**Subject: Response to Portion of NRC Request for Additional Information
Letter No. 44 – Safety Analysis – RAI Numbers 4.6-23, 4.6-23S01 and
4.6-27**

1. MFN 07-253 – Response to Portion of NRC Request for Additional Information Letter No. 44 – Related to ESBWR Design Certification Application – CRD System – RAI Numbers 4.6-23, 4.6-23S01 and 4.6-27.
2. MFN 07-253 – Response to Portion of NRC Request for Additional Information Letter No. 44 – Related to ESBWR Design Certification Application – Control Rod Drop Event Frequency Evaluation

RAI Numbers 4.6-23, 4.6-23 S01 and 4.6-27

Control Rod Drop Event Frequency Evaluation

**FAULT TREE FOR TOP GATE CRDDROP: CONTROL ROD UNCOUPLES
AND DROPS TO HOLLOW PISTON POSITION**

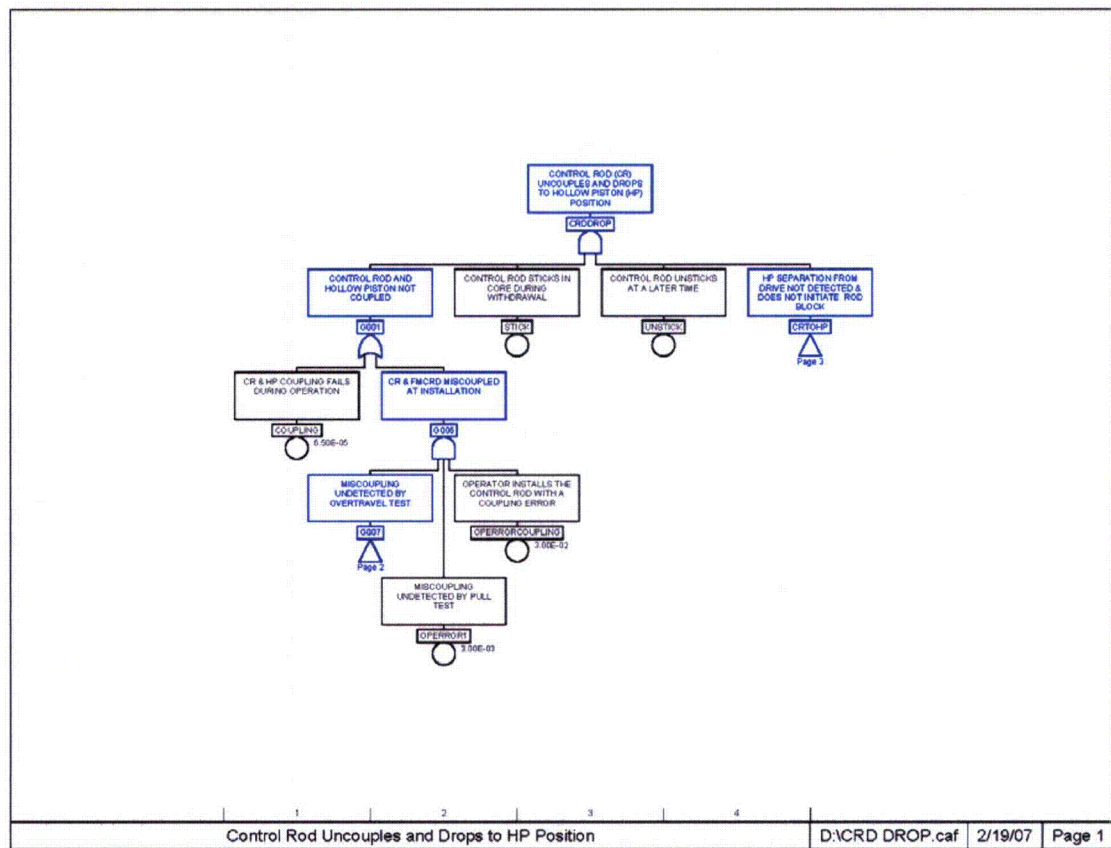
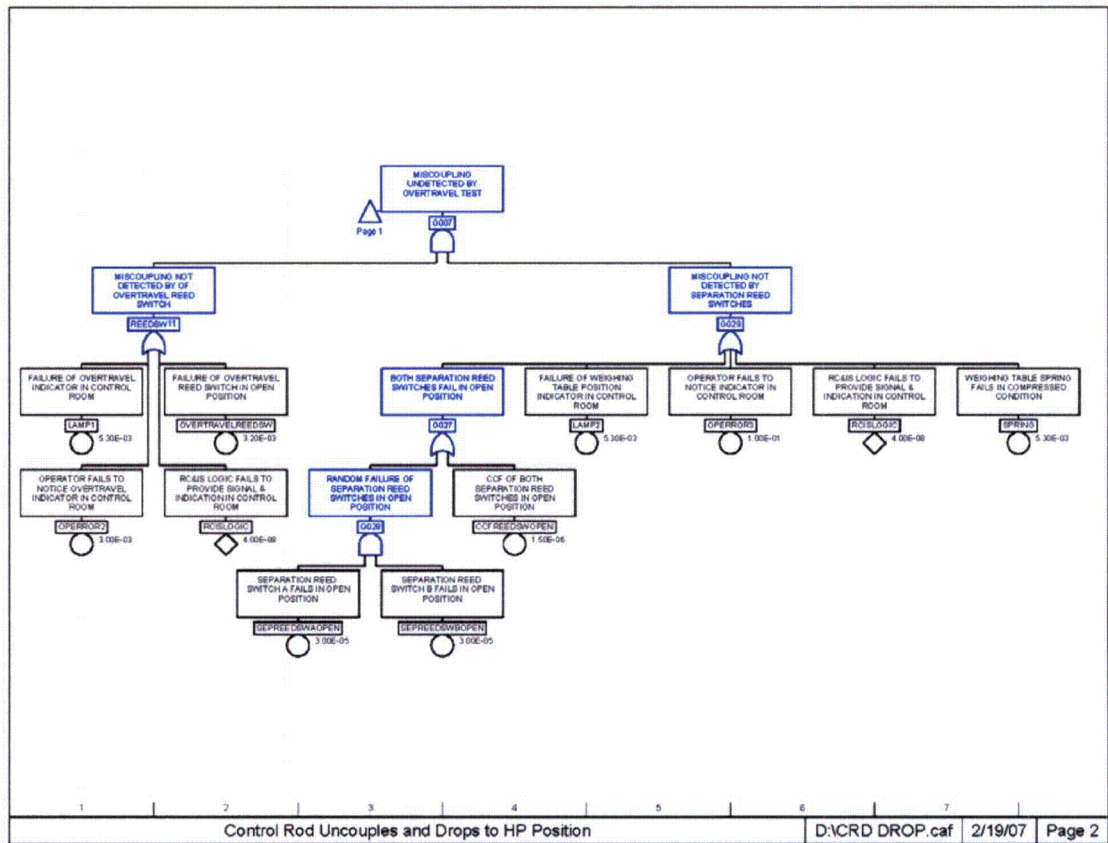
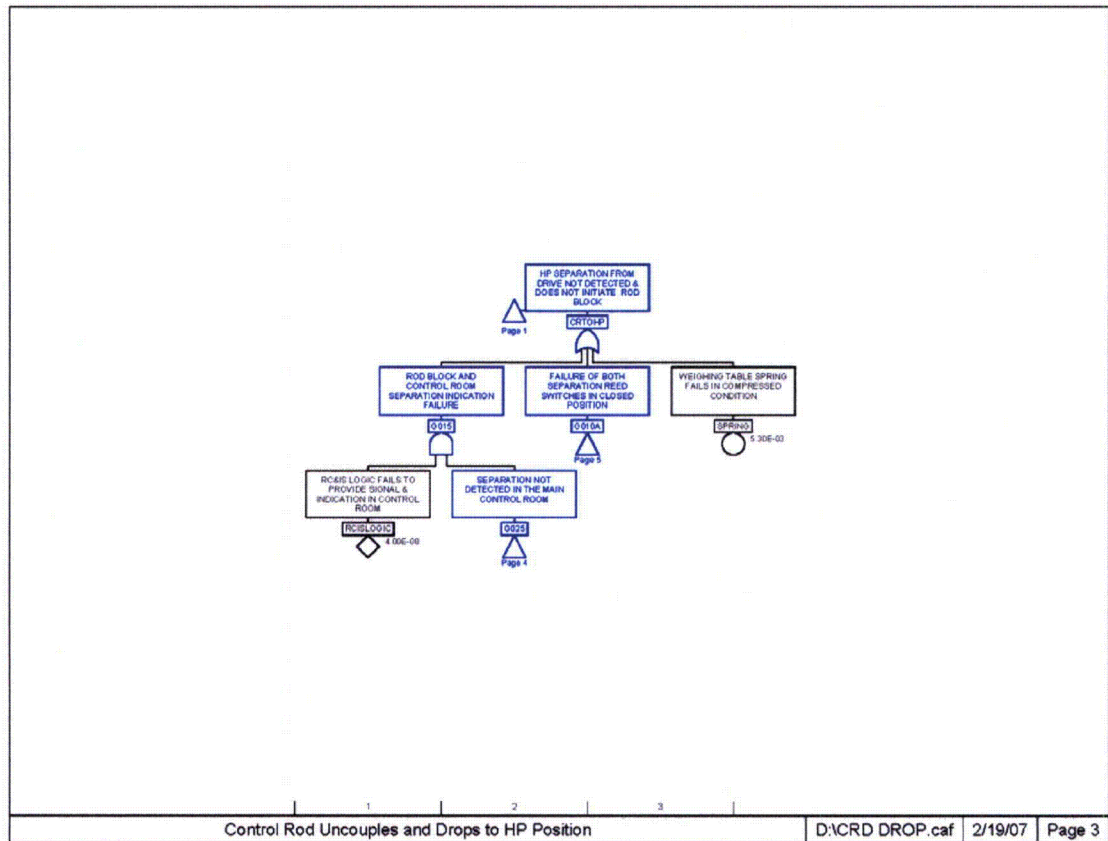
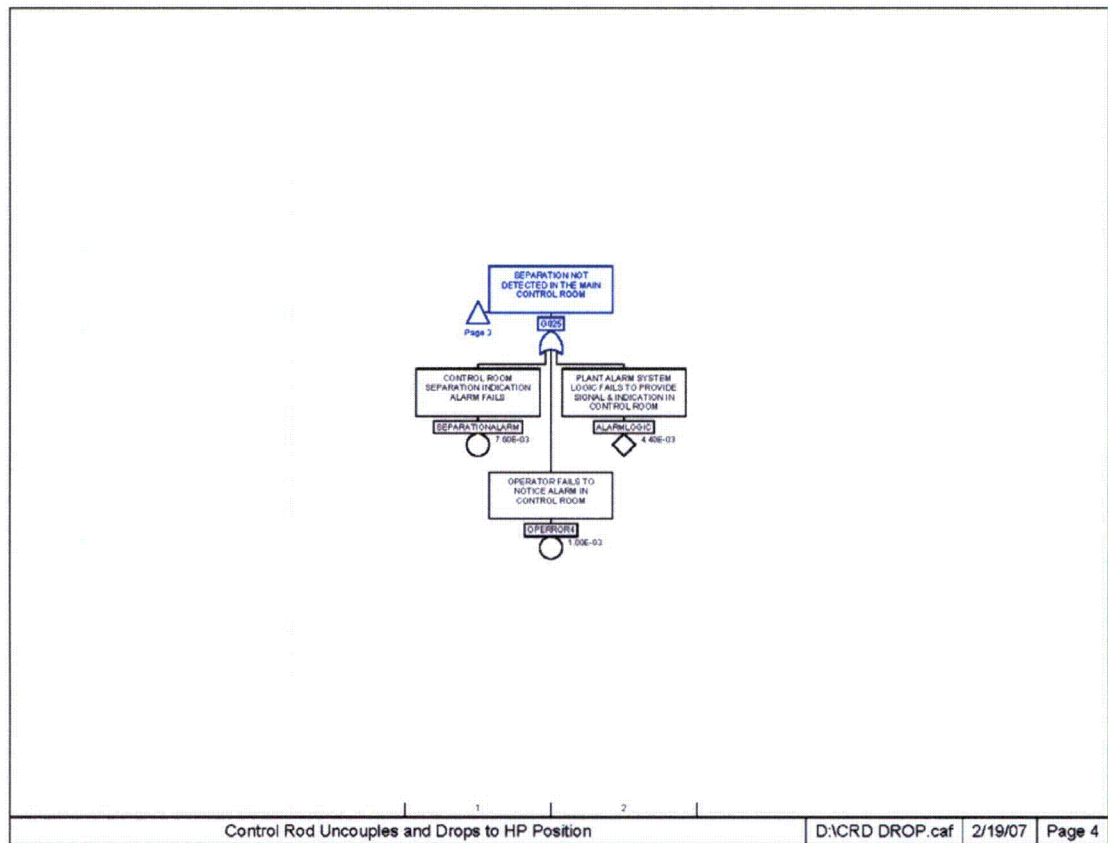
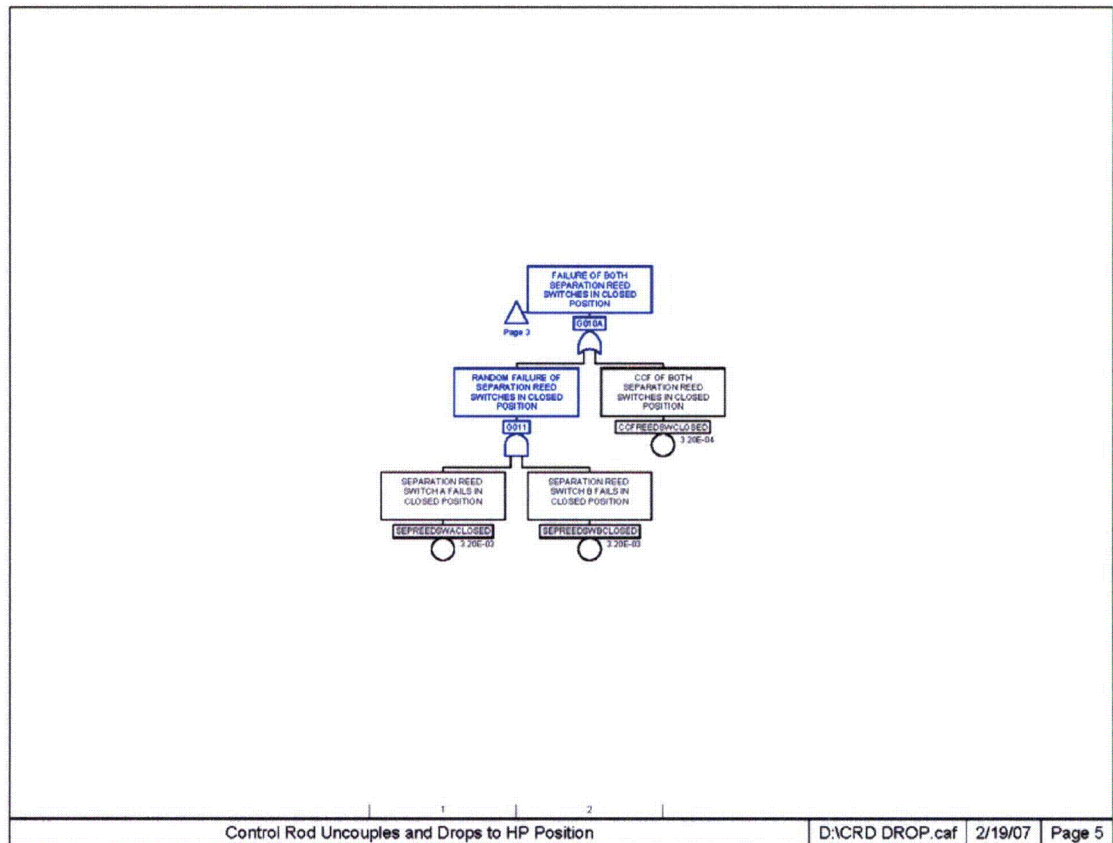
(b) Building upon the ABWR CRD Failure Modes and Effect Analysis (FMEA), discuss the probability and potential consequences for each scenario leading to an excess reactivity event.

The event frequency is estimated to be $3.7\text{E-}7$ per reactor-year.
